APPLICATION NO.	FILING DATE	FIRST NAMED INVENTOR	ATTORNEY DOCKET NO.	CONFIRMATION NO.	
10/624,649	07/23/2003	Robert R. Ricci	FS-00790	6899	
1055	7590 03/13/2007 & BERNSTEIN, P.L.C.		. EXAM	INER ·	
1950 ROLAND	CLARKE PLACE		HESS, DO	HESS, DOUGLAS A	
RESTON, VA 20191			ART UNIT	PAPER NUMBER	
	·	t	3651		
				·	
SHORTENED STATUTOR	Y PERIOD OF RESPONSE	NOTIFICATION DATE	DELIVER	Y MODE	
3 MO	NTHS	03/13/2007	FLECT	RONIC

Application No.	Applicant/a)	
	Application No.	Applicant(s)	
0.65	10/624,649	RICCI ET AL.	
Office Action Summary	Examiner	Art Unit	
	Douglas A. Hess	3651	
The MAILING DATE of this communication apperiod for Reply	pears on the cover sheet with the	correspondence address	
A SHORTENED STATUTORY PERIOD FOR REPL WHICHEVER IS LONGER, FROM THE MAILING D - Extensions of time may be available under the provisions of 37 CFR 1.1 after SIX (6) MONTHS from the mailing date of this communication. - If NO period for reply is specified above, the maximum statutory period - Failure to reply within the set or extended period for reply will, by statute Any reply received by the Office later than three months after the mailin earned patent term adjustment. See 37 CFR 1.704(b).	ATE OF THIS CO

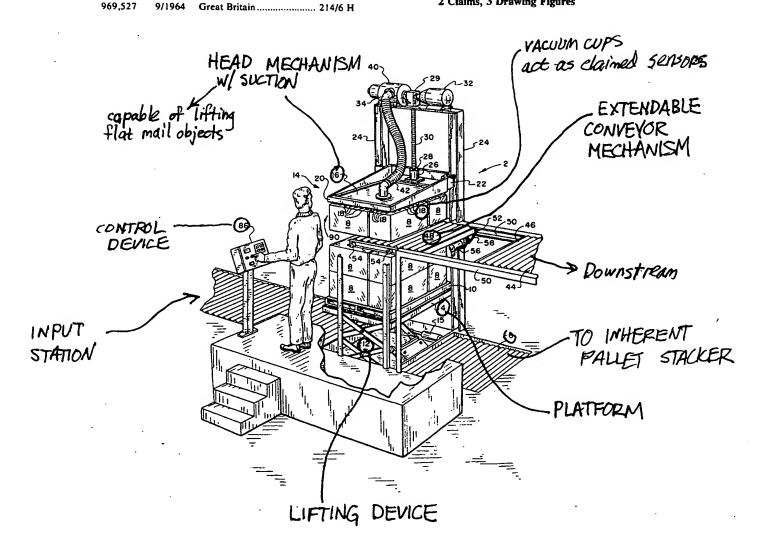
- (b) the invention was patented or described in a printed publication in this or a foreign country or in public use or on sale in this country, more than one year prior to the date of application for patent in the United States.
- 2. Claims 1-3, 8, 11-16 are rejected under 35 U.S.C. 102(b) as being anticipated by Jones (US Pat. No. 3,780,884).

See attached marked up cover sheet of Jones depicting the claimed features.
